**CITY OF LA VISTA**  
**MAYOR AND CITY COUNCIL REPORT**  
**AUGUST 18, 2015 AGENDA**

<b>Subject:</b>	<b>Type:</b>	<b>Submitted By:</b>
APPLICATION FOR PUD ORDINANCE AMENDMENT, ◆ RESOLUTION (2) FINAL PUD PLAN & CONDITIONAL USE PERMIT— COMFORT SUITES LOT 1, SOUTHPORT EAST REPLAT TWELVE (NE OF McDERMOTT PLZ. & EASTPORT PKWY.)	ORDINANCE (1) RECEIVE/FILE	ANN BIRCH COMMUNITY DEVELOPMENT DIRECTOR

**RECOMMENDATION REPORT**

CASE NUMBER: 2015-CUP-02  
2015-PUD-04

TITLE: LANDSCAPE PLAN

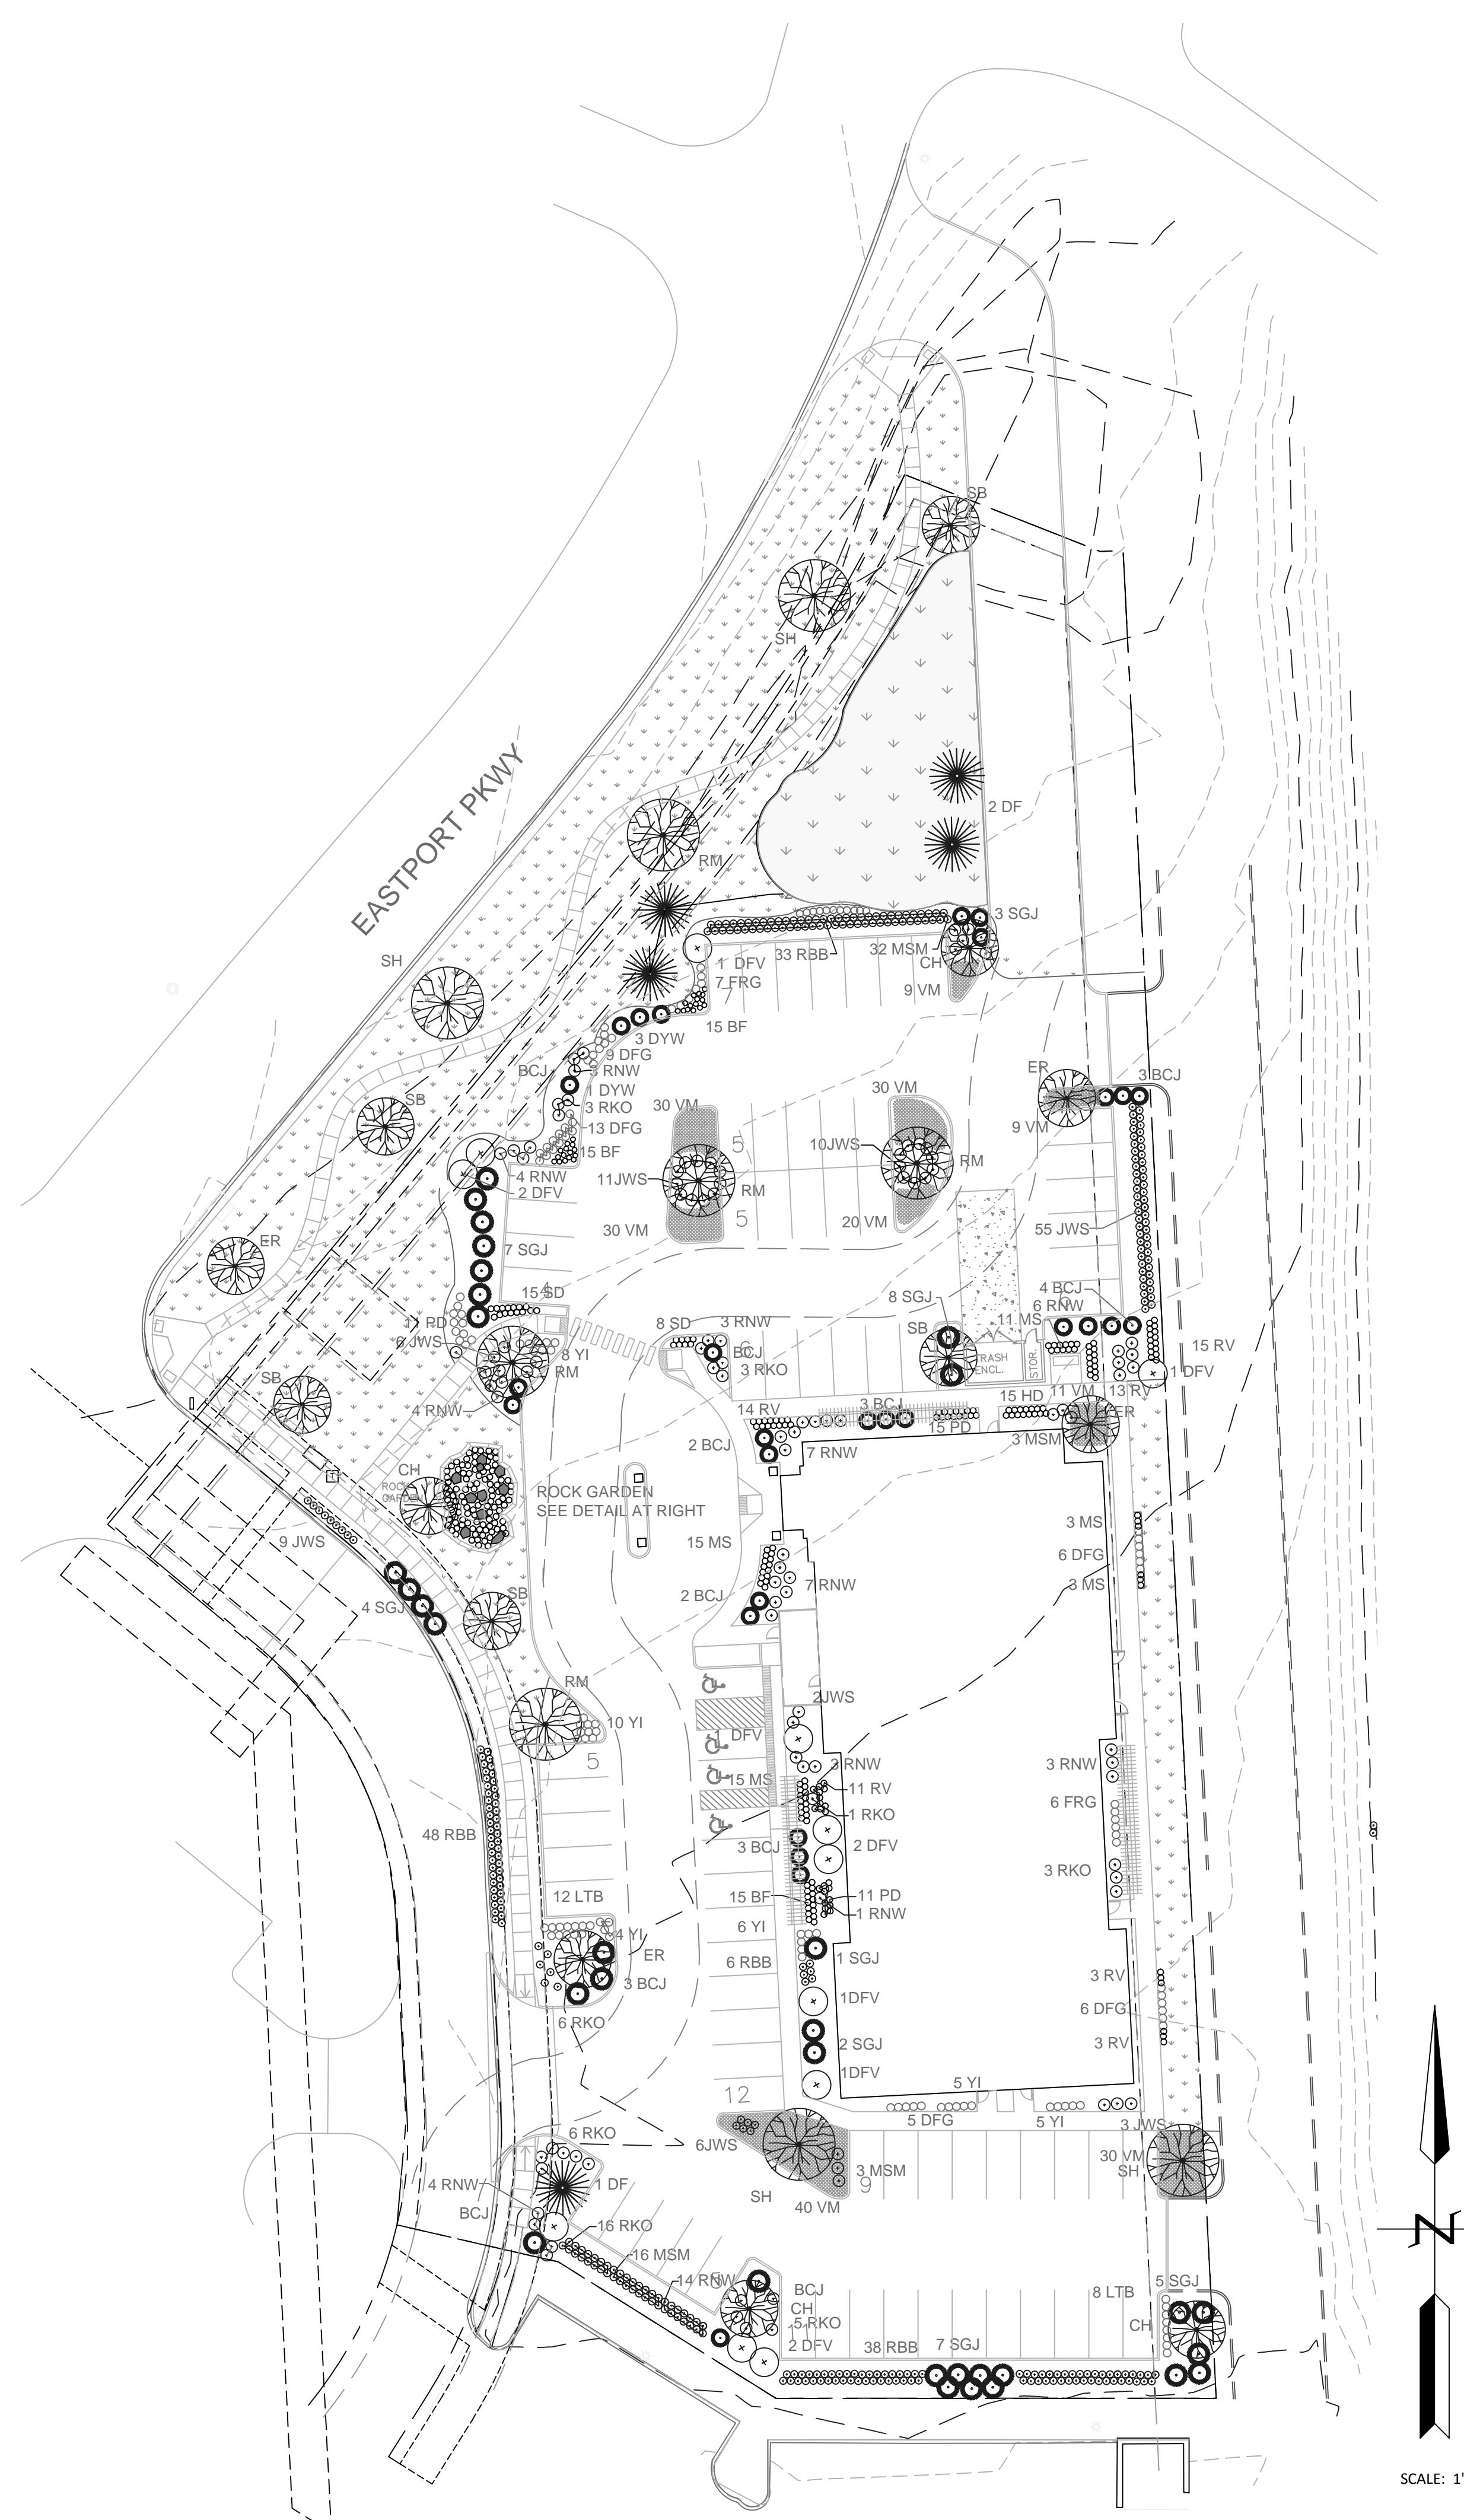
1. Previous comments on plant list sizes have been incorporated.
2. Landscaping at the storm water detention structure is hatched as sod. Coordinate with civil and revise landscaping design to propose plantings that will perform well in this location.
3. Several plantings along the east property line are shown into the adjacent property. Revise so all plantings are on the Comfort Suites property.
4. Strip of sod shown under pergola location on west side seems like it will be hard to maintain and would do better as additional plantings and mulch.
5. Plantings at the rock garden and monument sign are not shown (assuming there will be some?). Watch plantings at monument sign for size a full growth.

See revised landscape plan.
